### REMARKS

Prosecution on the merits has been closed under the doctrine of *Ex Parte Quayle*. No changes have been made in claims 1 and 2 except for changes necessary to remove various informalities, especially errors in the equations presented in claim 2.

FIG. 4

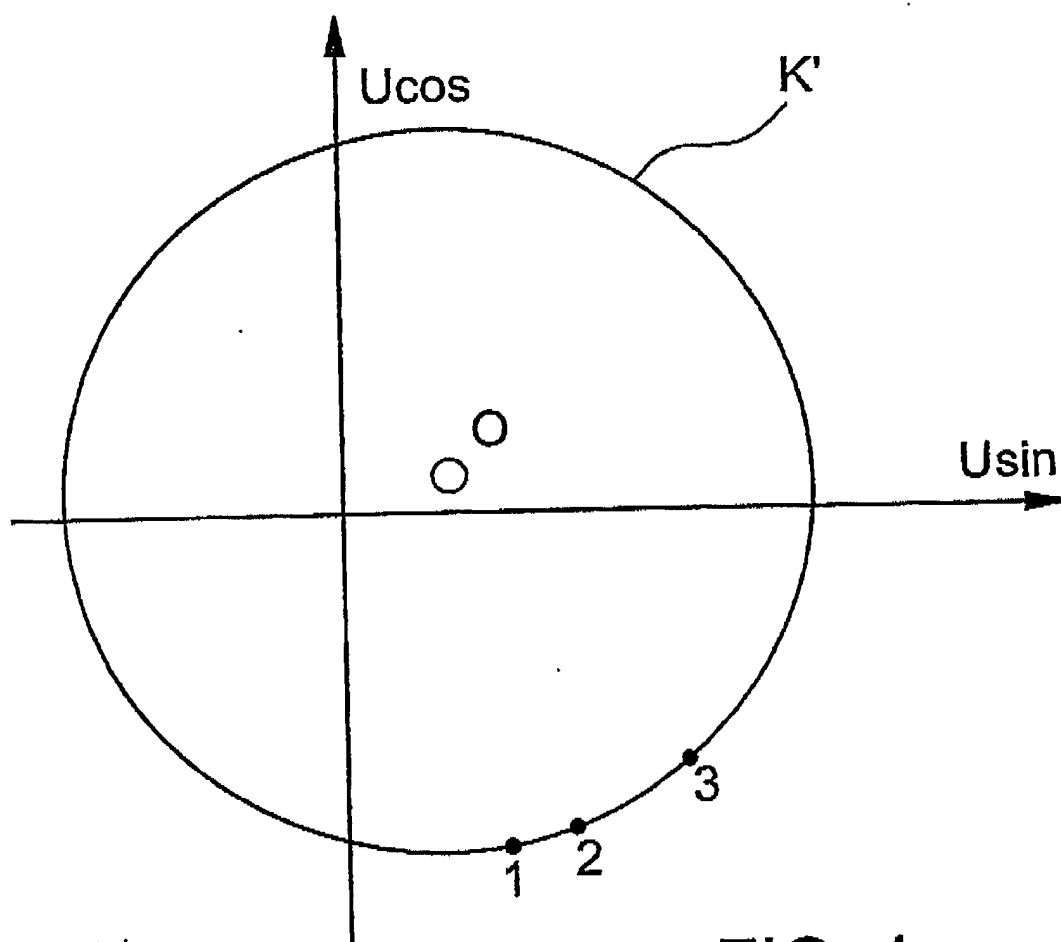
A sketch showing the suggested change in Fig. 4 has been attached to this amendment. The suggested change is shown in RED. Approval of the change, which amounts to translation of a German word into English, is respectfully requested.

Value Pairs:  
~~Wertepaare:~~  
 $U_{\sin}(1), U_{\cos}(1)$   
 $U_{\sin}(2), U_{\cos}(2)$   
 $U_{\sin}(3), U_{\cos}(3)$
